Access Compliance Report

Public Rights-of-Way

(Curb Ramps)

Intersection ID: 10025885	Main Street: ELIZABETH_AV	Cross Street: N/A	Location: S
ADA ID: 702758721307	Ramp Type: Perp	Initial Pass/Fail: Pass	Overall Compliance: No
Codes/Mitigation Info/Possible Solution		Field Measurements/Component Compliance	
Severity Score: 7.75

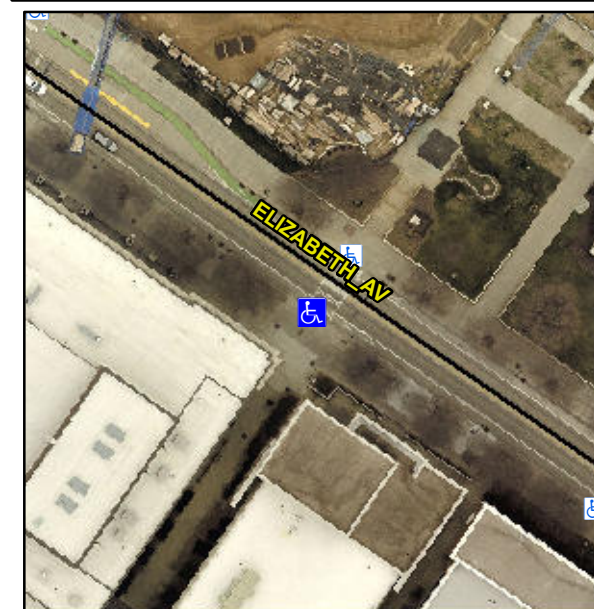
**Not Found, R304.5.3, R304.2.3,
R304.5.4**

Compliance	Description	Data	Compliance	Description	Data
N/A	Ramp Length (in)	84.0	Yes	Ramp Slope (%)	8.1
Yes	Ramp Width (in)	96.5	No	Ramp XSlope (%)	4.3
N/A	Flare Type LT	Sloped	N/A	Flare Type RT	N/A
N/A	Flare Slope LT (%)	10.1	Yes	Flare Slope RT (%)	1.3
N/A	Flare Traversable LT?	Yes	N/A	Flare Traversable RT?	Yes
Yes	Landing Length (in)	60.0	Yes	DWS Provided?	Yes
Yes	Landing Width (in)	96.5	Yes	DWS Contrast?	Yes
Yes	Landing Slope (%)	0.3	Yes	DWS Length (in)	24.5
Yes	Landing X Slope (%)	3.3	Yes	DWS Full Width?	Yes
N/A	Landing Curb? (Y/N)	No	Yes	DWS Offset (in)	0.0
N/A	Shared Landing?	No			
Yes	Gutter Ponding?	No	No	Gutter Slope (%)	7.9
Yes	Gutter Lip Ht (in)	0.0	No	Gutter X Slope (%)	4.1
N/A	Painted X Walk1?	Yes	N/A	Painted X Walk2?	N/A
	X Walk 1 Direction	To NE		X Walk 2 Direction	N/A
N/A	X Walk 1 Width (in)	140.0	N/A	X Walk 2 Width (in)	N/A
	X Walk 1 Slope (%)	1.3		X Walk 2 Slope (%)	N/A
	X Walk 1 X Slope (%)	3.5		X Walk 2 X Slope (%)	N/A

**Remove & Replace Entire Ramp.
Remove & Replace Gutter.**
